FIELD CHANGE SHEET

FED ROAD REG. NO.	STATE	CONTRACT NO.	SHEET NO.	TOTAL SHEETS
1	N.Y.	D259317	25F1	61
SH 5243, SANITARIA SPRINGS - HARPURVILLE				
NYS ROUTE 7				
TOWN OF COLESVILLE				
BROOME COUNTY				
P.I.N. 980434		B.I.N. 1003760

NOTES:
 SHEET 25 F1 VOIDS ORIGINAL SHEET 25
 THIS FIELD CHANGE SHEET PEDESTAL REMOVAL AND NOTE CHANGE

NYS ROUTE 7/BELDEN BROOK

MISCELLANEOUS DETAILS

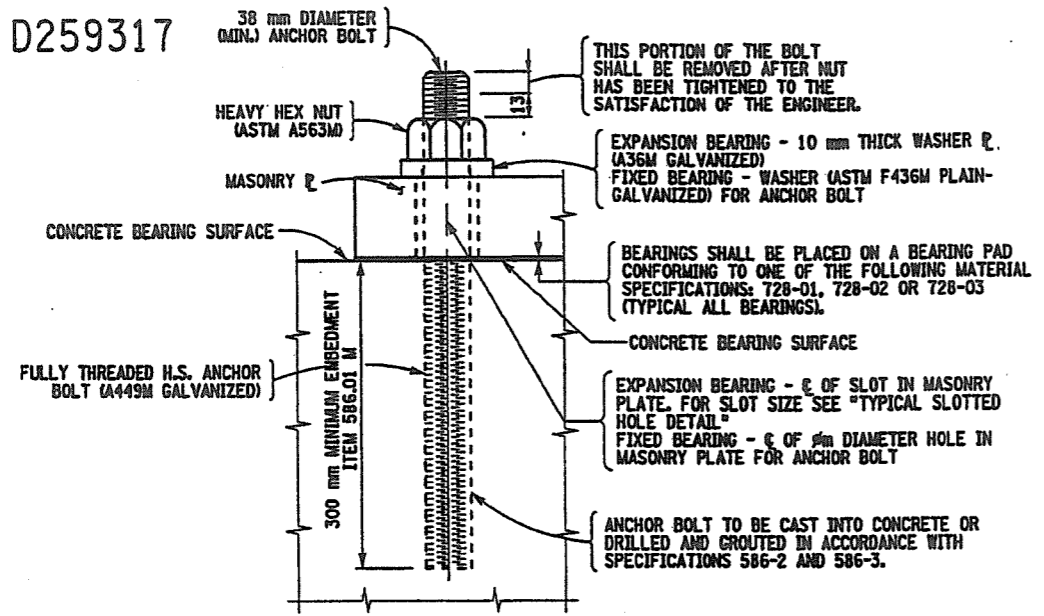
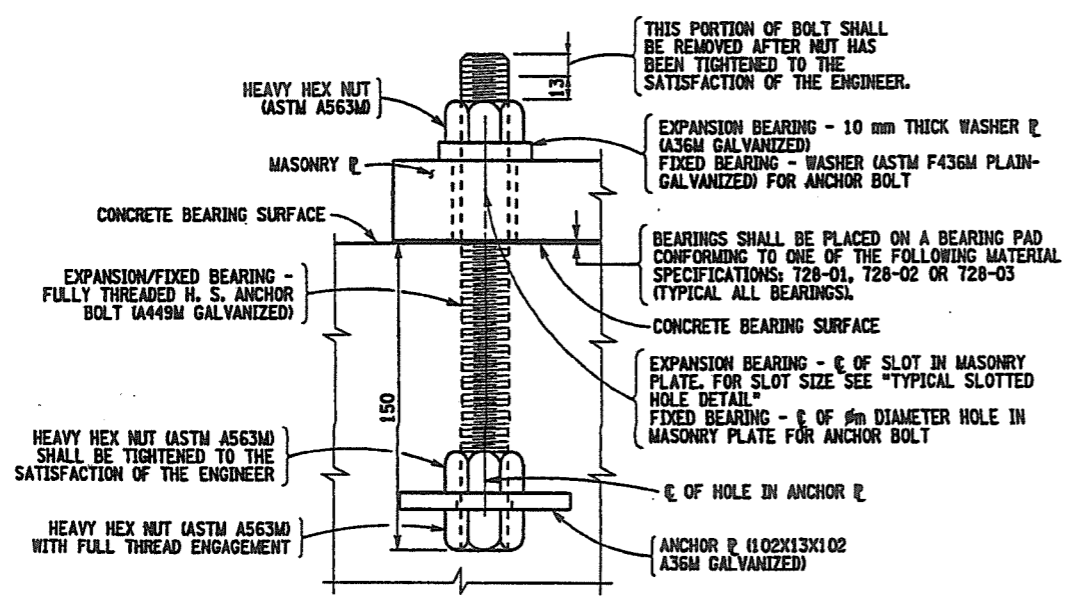
NOTES:
 SHEET 35 F1 VOIDS ORIGINAL SHEET 35
 THIS FIELD CHANGE SHEET DENOTES ANCHOR BOLT ASSY.
